Service Bulletin

Bulletin No.: PI0659A

Subject: Groan, Squeak or Rubbing Type Noise When Turning Steering Wheel

Models: 2010-2013 Buick LaCrosse
2012-2013 Buick Regal
2013 Chevrolet Malibu

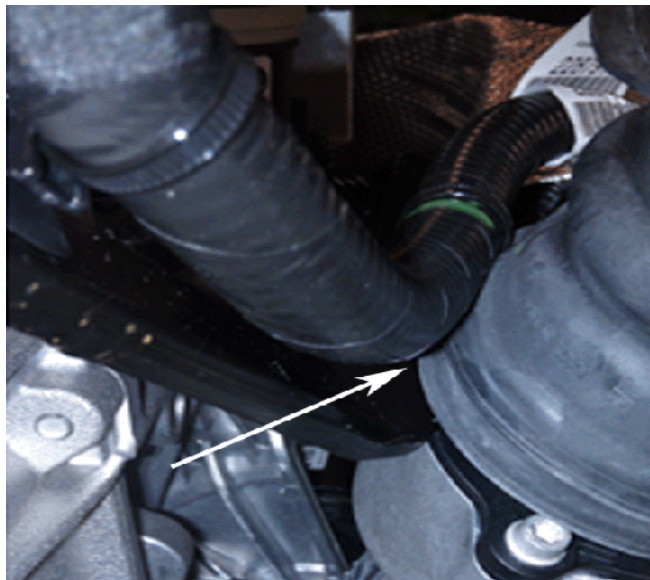
Some customers may comment on a rubber squeak type noise when turning the steering wheel. This condition may be caused by the seal for the intermediate shaft, located at the front of dash, rubbing on the rotating intermediate steering shaft. Refer to the pictures above. On electronic power steering (EPS) equipped vehicles, the EPS wire harness bracket may be contacting the steering column seal.

Technicians should inspect the steering column seal for proper installation by repositioning the inner intermediate steering shaft boot assembly to gain access. Inspect the seal at the front of the dash where the intermediate steering shaft passes through from the steering gear. Ensure that the seal is centered in the opening and around the intermediate steering shaft as shown above. If the seal is out of position, replace the steering column seal following the steps below.

For electronic power steering (EPS) equipped vehicles, if the steering column seal is in position, technicians should inspect the EPS wire harness bracket if equipped and make sure that the bracket is not contacting the steering column seal. If contact is observed, manually adjust the EPS bracket to obtain an 8-12 mm (0.31-0.47 in) clearance from the steering column seal.
